HONDA ServiceNews

ASN 22447-40074 (0808)

Modify the Universal Holder

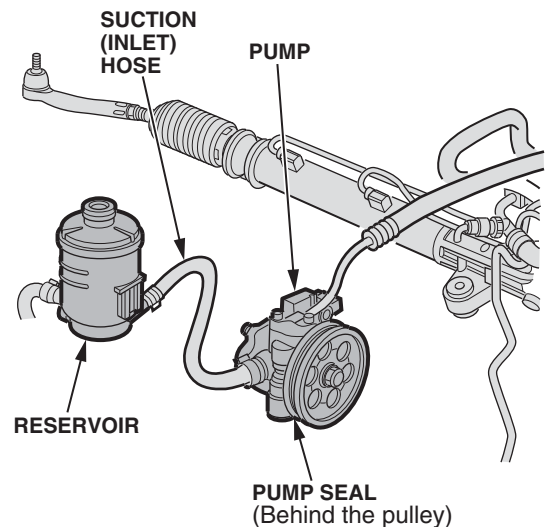
The original pins on the Universal Holder (T/N 07725-0030000) are too short to completely engage the holes in a power steering pump pulley. To improve this tool, press out the original pins, and install an 8 x 30 mm bolt into each hole.

Pages 14-144 and 14-174: Change the Exploded Views to look like this:

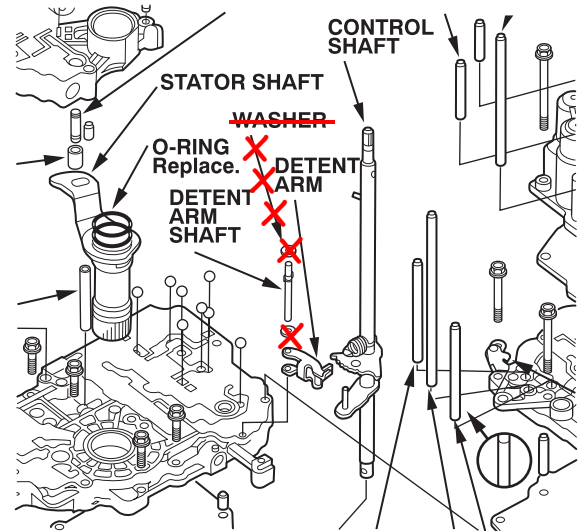
The Automatic Transmission section of the '01 Civic S/M calls out washers for the detent arm shaft. There are *no* washers used for the detent arm shaft in '01 Civics. Make these changes in your copies of the S/M:

Page 18-22, Reassembly, step 1: Change the text and illustration to read and look like this:

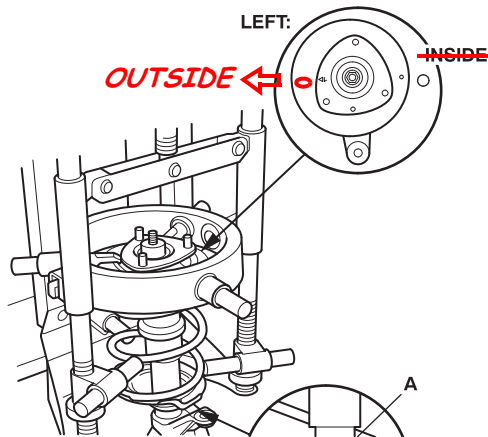
In the '01 Civic S/M, step 1 on page 18-22 and on page 18-23 has the wrong orientation for the upper spring seat. Make these changes in your copies of the S/M:

1. Install all the parts except the self-locking nut onto the damper unit by referring to the Exploded View. Align the bottom of the spring (A) and the stepped part of the lower spring seat (B) as illustrated. ~~Align the upper spring seat so that the small hole in it is on the engine compartment side when it is installed in the body.~~

The hole in the upper spring seat and the arrow on the damper mounting base must point toward the knuckle mounting area.

Page 23-32: Change the circuit diagram to look like this:

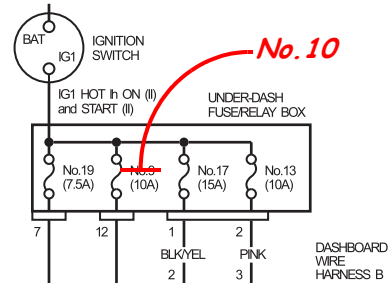
The Restraints section of the '01 Civic S/M has the wrong fuse number called out in the driver's under-dash fuse/relay box. The No. 19 (7.5 A) fuse should be No. **10** (7.5 A). Make sure you include these changes in your copies of the S/M:
